ADDENDUM 001

Date: **May 27, 2026**
To: **Construction Documents, Dated 05.18.26**
Project: **#3038 ASU Career Readiness, Education, & Skills Training Center**

1 MECHANICAL ROOF PLAN

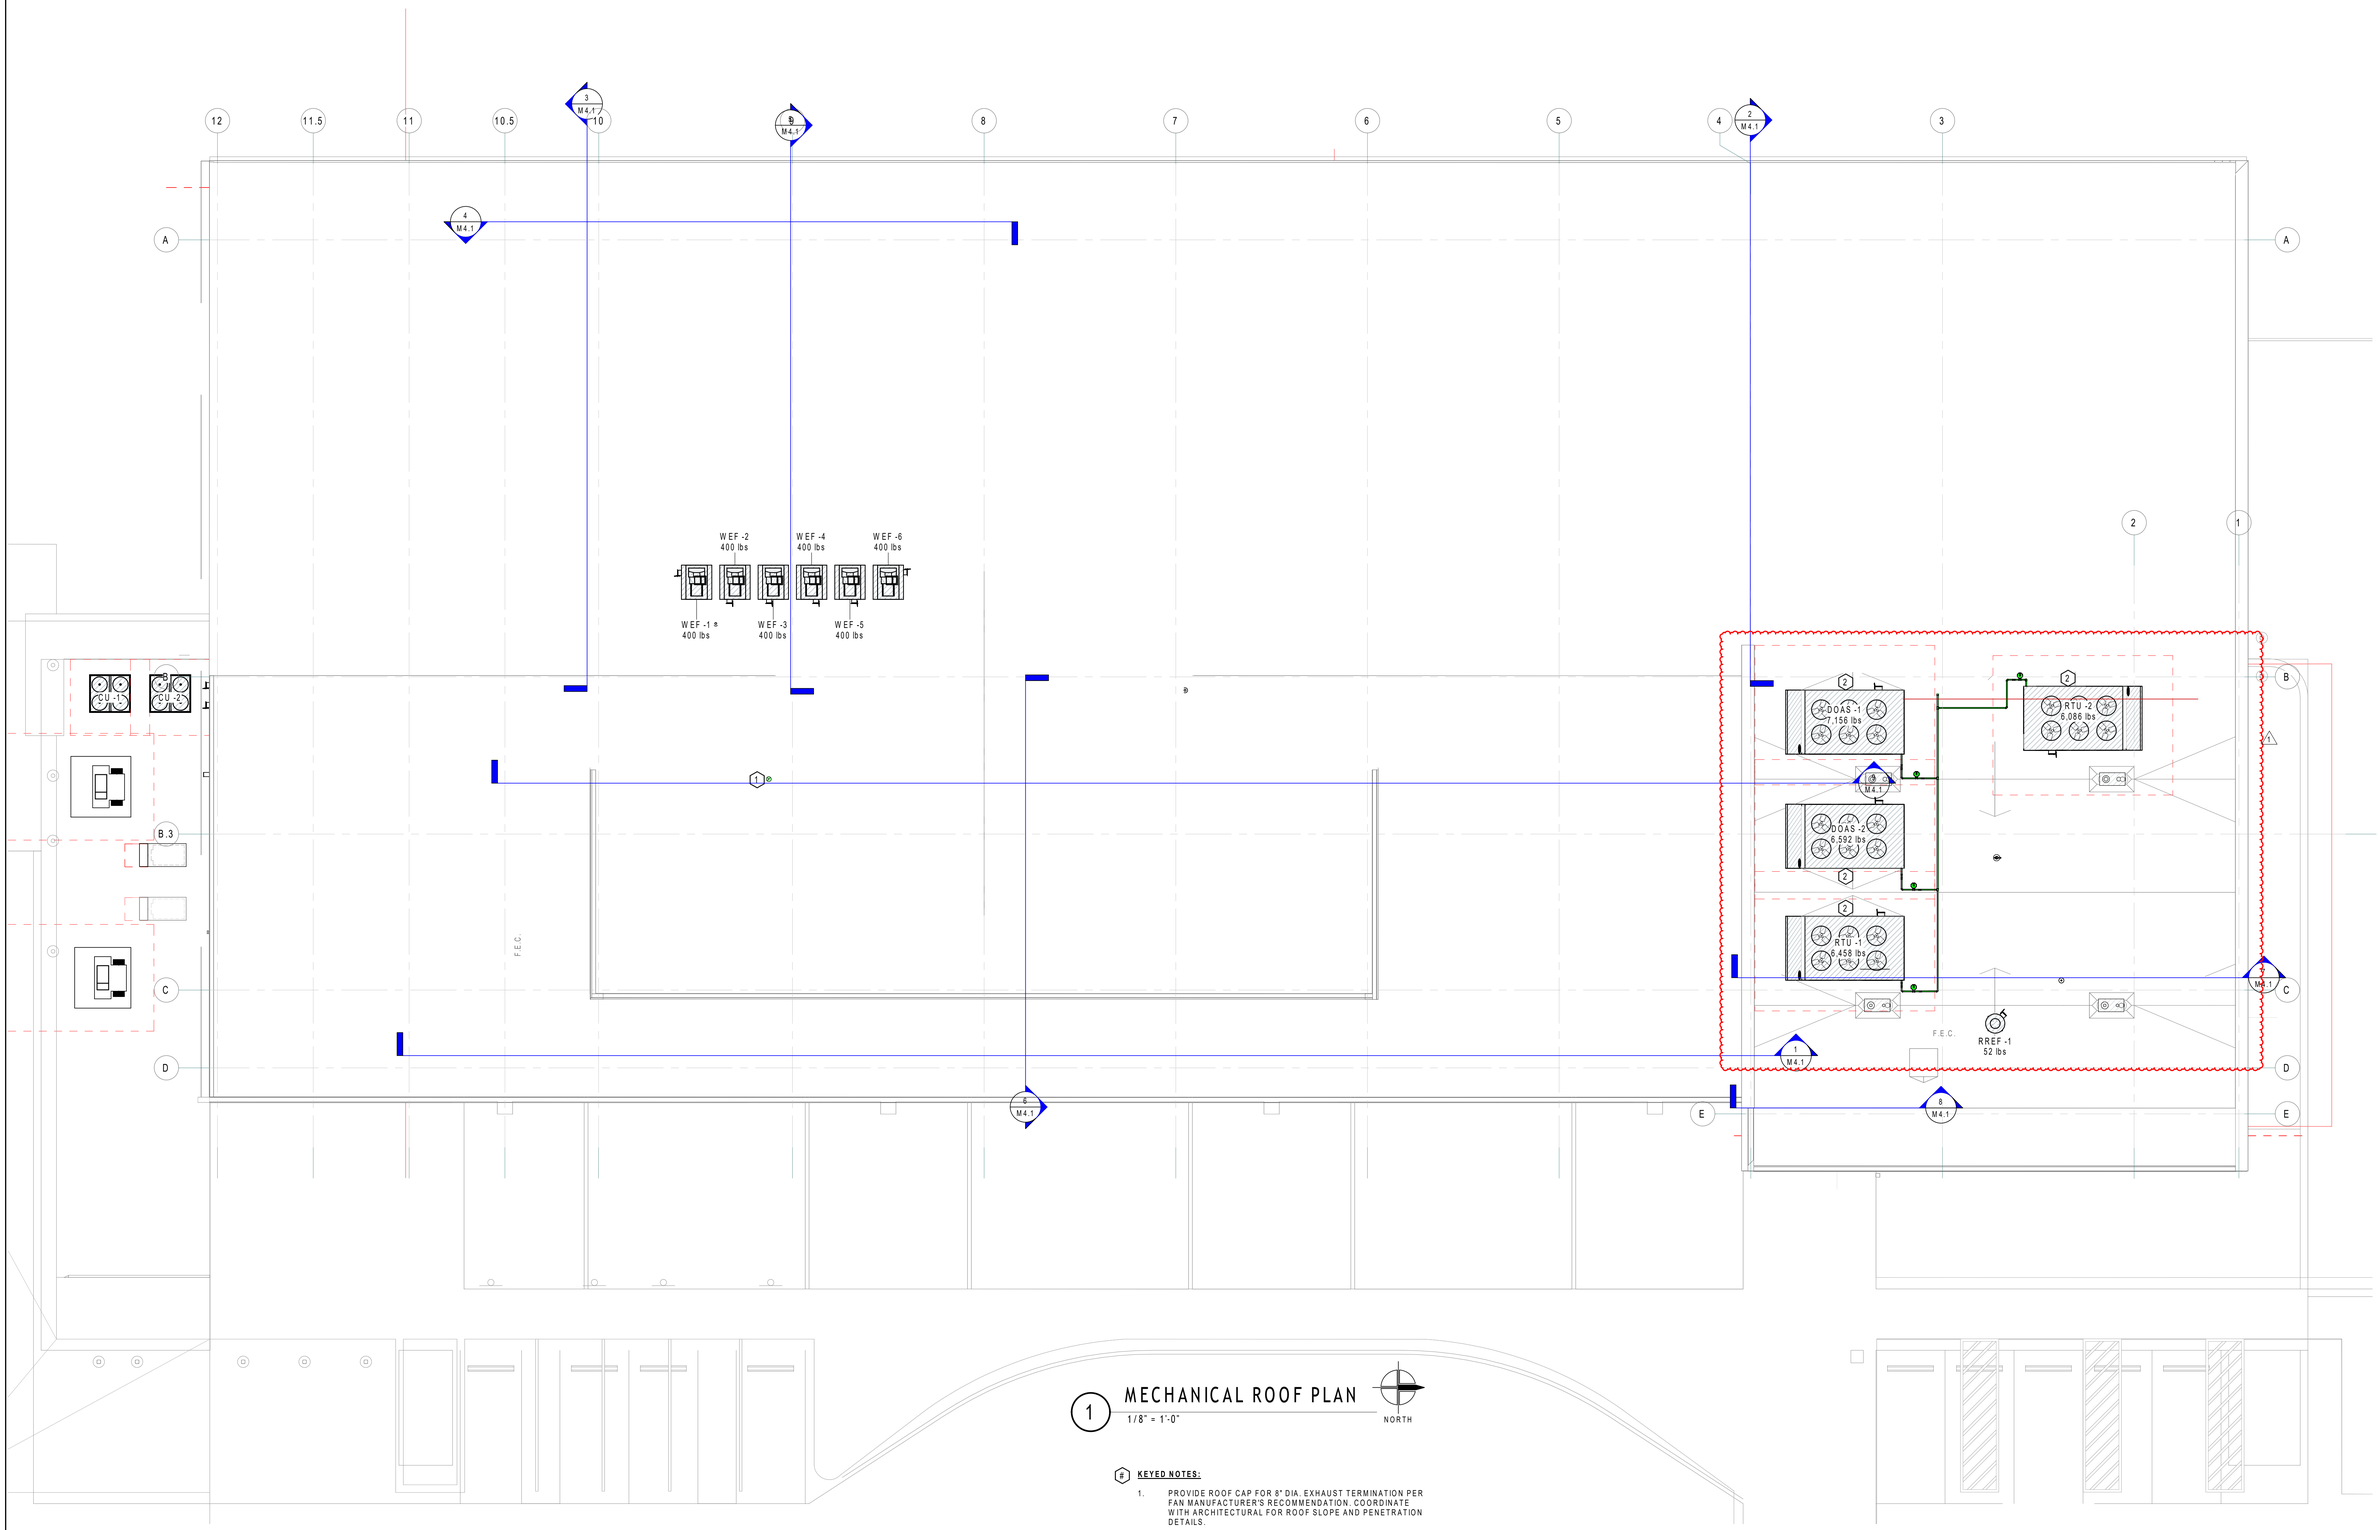
l. **REPLACE** Sheet M2.2 HVAC ROOF PLAN with the attached for the following revisions:

1. **REVISE** mechanical equipment locations

2 STORM DRAIN RISER

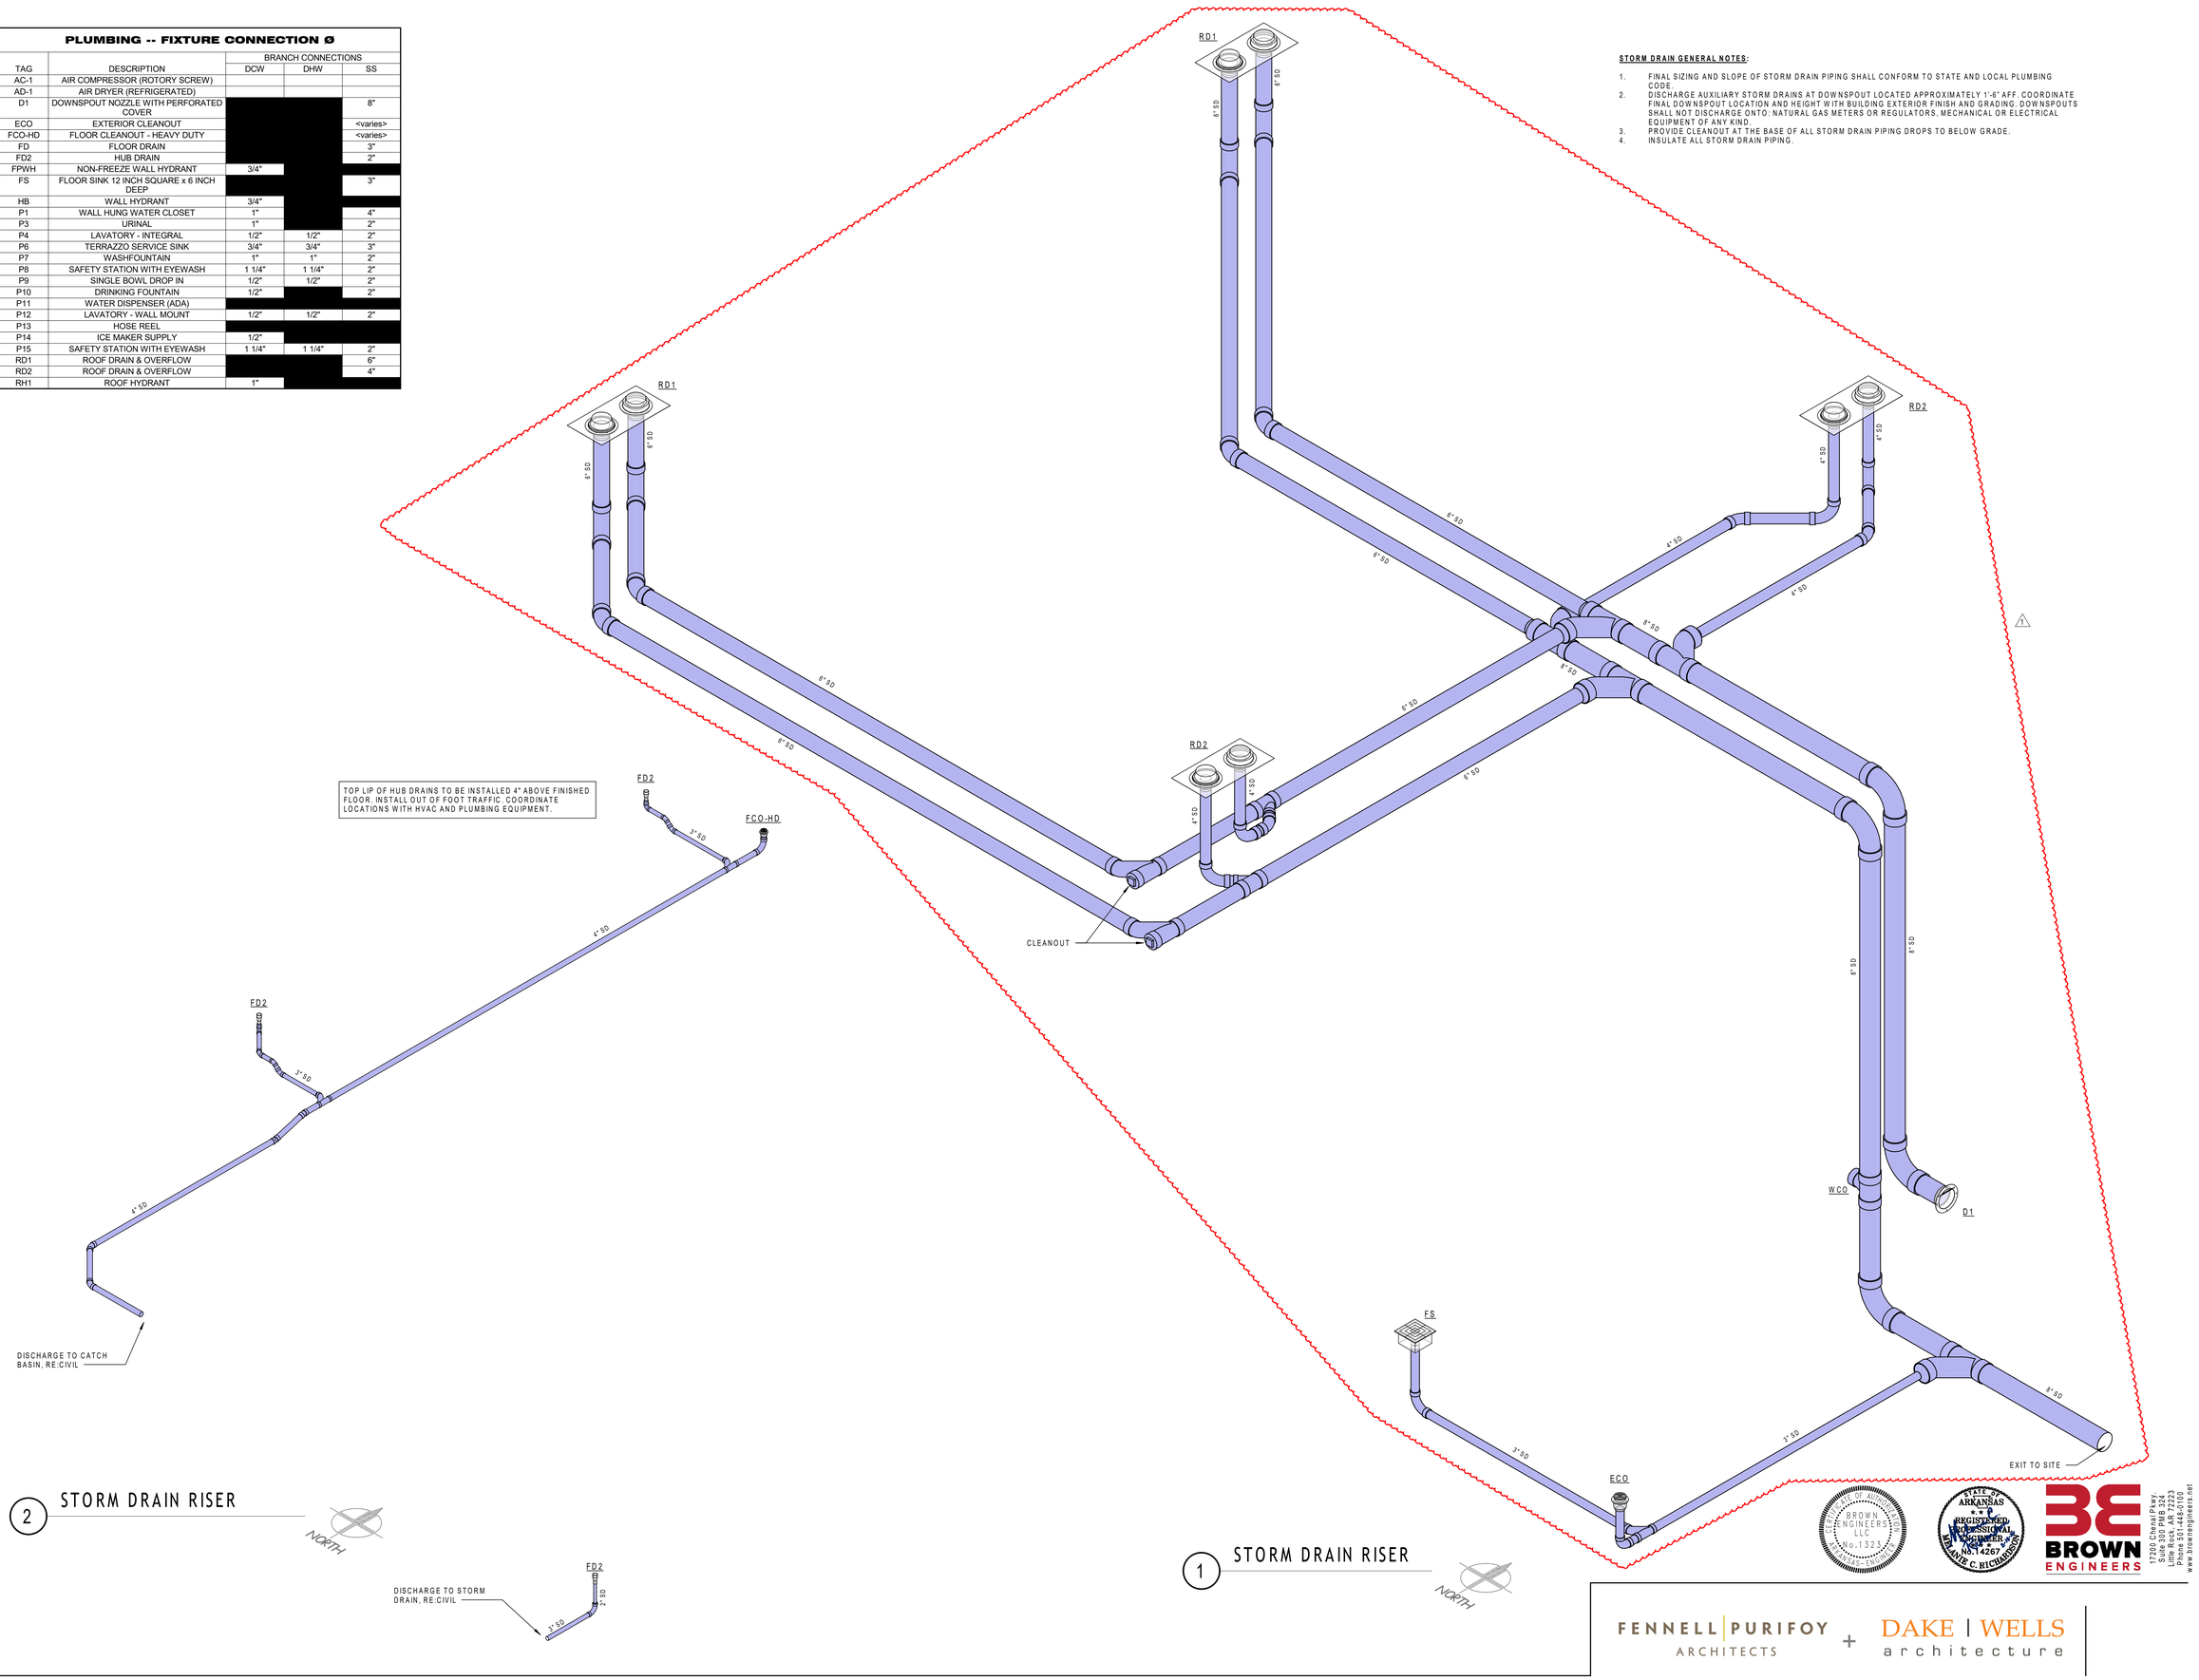
m. **REPLACE** Sheet M3.1 MECHANICAL SCHEDULES I with the attached for the following revisions:
    1. **REVISE** AHU Packaged Schedule
    2. **REVISE** Outside Air Unit Schedule
n. **REPLACE** Sheet M4.1 MECHANICAL SECTIONS I with the attached for the following revisions:
    1. **REVISE** mechanical equipment locations
    2. **ADD** Keynote #3 for Unit Heights
o. **REPLACE** Sheet M5.2 MECHANICAL DETAILS II with the attached for the following revisions:
    1. **REVISE** Detail 1 – AHU ROOFTOP PENETRATION
p. **REPLACE** Sheet P2.0 SANITARY FLOOR PLAN & Sheet P5.10 STORM DRAIN RISER with the attached for the following revisions:
    1. **ADD** (2) Roof drains
